The Glitch & The Fix, May 2017

## Double Duty

**Figure 1:**

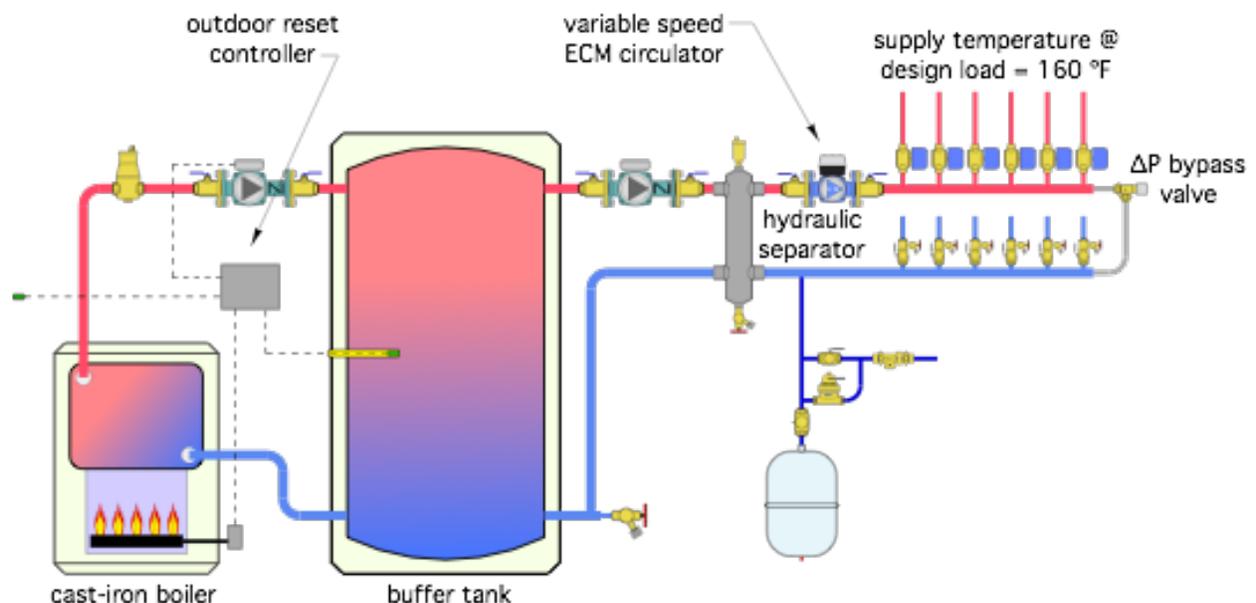
A heating contractor is asked to create a multi-zone system that will supply 160 °F water to several zones of heat emitters at design load conditions. A conventional cast-iron gas-fired boiler will be used. Because of the extensive zoning, the contractor decides to use a buffer tank between the boiler and zone circuits to prevent boiler short cycling. A hydraulic separator is also selected to isolate the pressure dynamics created by the variable speed circulator from those created by the other circulators in the system. To maintain stable room temperature, the water temperature delivered from the buffer tank will vary based on outdoor reset control.

Can you identify several errors or suggest some more refined design approaches for this system?

First, it is not necessary to use *both* a buffer tank and a hydraulic separator as shown in figure 1. A buffer tank, when properly piped, can provide both buffering and hydraulic separation. the key is to keep the headers on the load side of the tank short and generously sized. The flow resistance through these headers, combined with extremely small head loss through the buffer tank separates the pressure dynamics of the variable speed circulator from that of the boiler circulator. The hydraulic separator as well as the circulator between it and the buffer tank can be eliminated.

2. A differential bypass is not needed, nor should it be present in a system where differential pressure is controlled by a variable speed circulator. If a differential pressure bypass valve is already present, it should be fully closed.

3. Although the water temperature returning to the boiler under design load conditions should be high enough to prevent sustained flue gas condensation, this will not be the case under low load conditions. Thus, the conventional boiler should be protected against sustained flue gas condensation by a high flow capacity 3-way thermostatic mixing valve, or other anti-condensation detailing. Some outdoor reset controllers have a minimum supply water temperature settings that is intended to prevent flue gas condensation, but using this feature limits how low the water temperature supplied to the heat emitters can be. This compromises the stable interior comfort benefits offered by “full range” outdoor reset control.

4. Adding a float type air vent to the top of the buffer tank.
5. Adding a pressure relief valve to the boiler.
